Project Title: Valadao – Subdivision Appeal  
Address: 1820 Pickett Rd., McKinleyville, CA 95519  
Assessor's Parcel # 510-381-021-000  
Record Number: PLN-2021-17560-APPEAL  
Board of Supervisors File Number: BAI-23-1593  
[planningclerk@co.humboldt.ca.us](mailto:planningclerk@co.humboldt.ca.us)

We hereby appeal the November 16, 2023 decision of the Humboldt County Planning Commission, regarding the Valadao Subdivision. We ask the Board of Supervisors to:

Valadao Subdivision  
1820 Pickett Rd. MCK  
Parcel 510-381-021-000  
PLN-2021-17560-APPEAL  
BOS File BAI-23-1593

Exhibit I

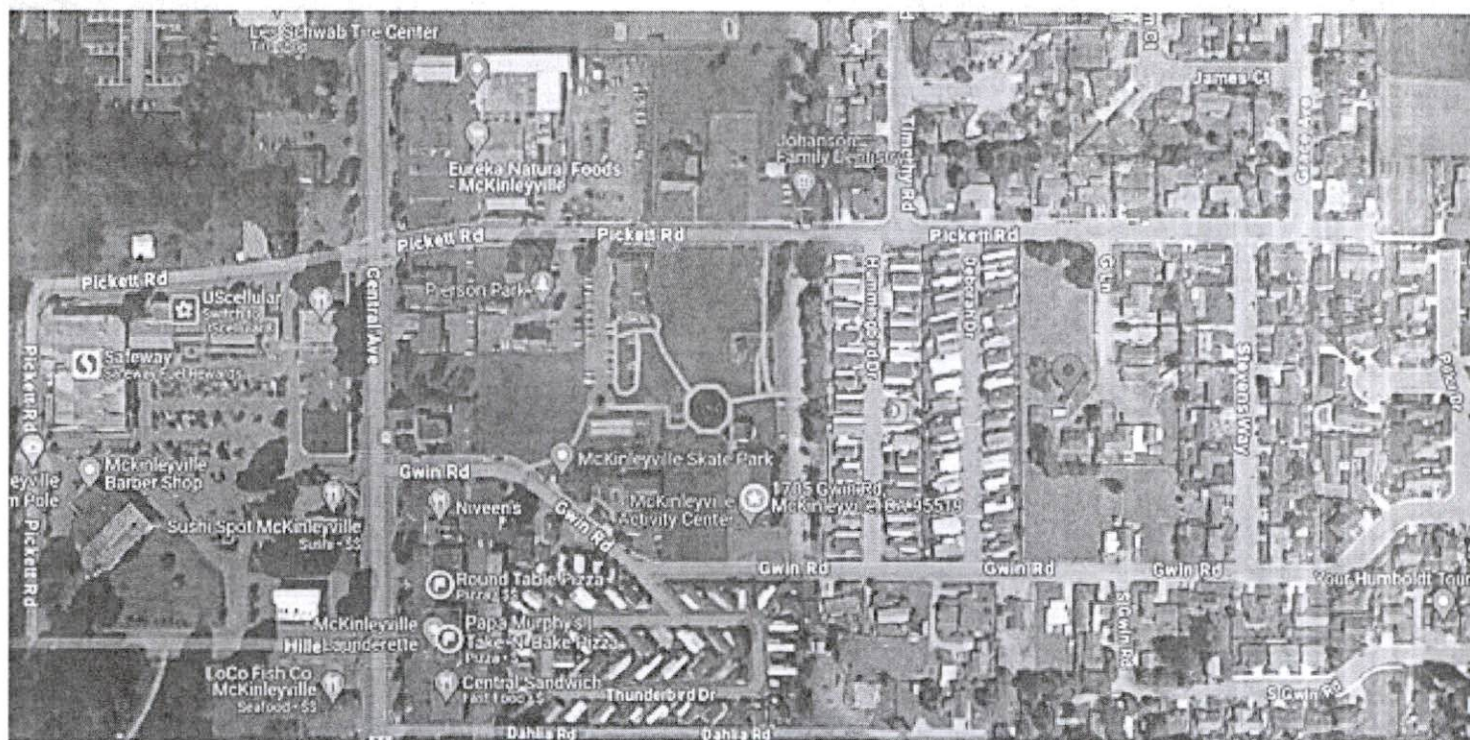
- d) The proposal is in our McKinleyville Town Center, which will one day be our “Old Town”  
*(See Google Satellite Map at Exhibit I.)*
- Central Avenue is the Business Loop Exit off North and South Highway 101

## Exhibit II

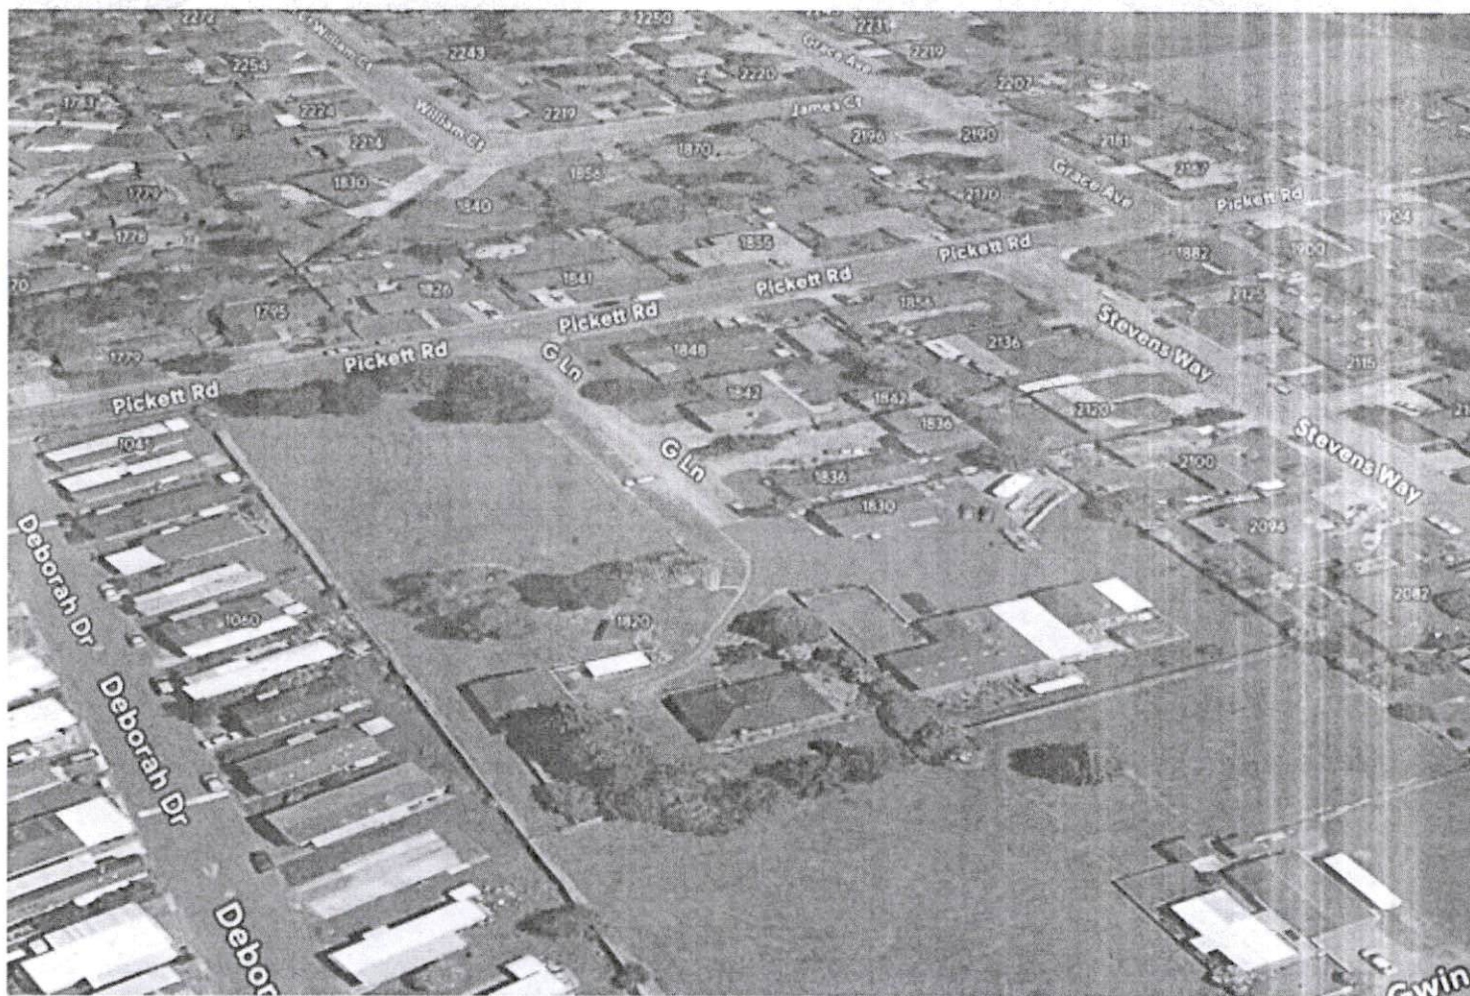
- f) According to the General Plan, Design Review can be used to ensure compatibility with neighborhood character. **(See Exhibit II for a Google satellite image.)**

- The surrounding area is *one-story* single-family homes, each on 1/3 acre.

- One single-story, quiet, well maintained. Senior mobile home park is adjacent to the parcel
- The proposal is 60 giant Two-Story Apartments on 2.11 acres. Density—29 units per acre
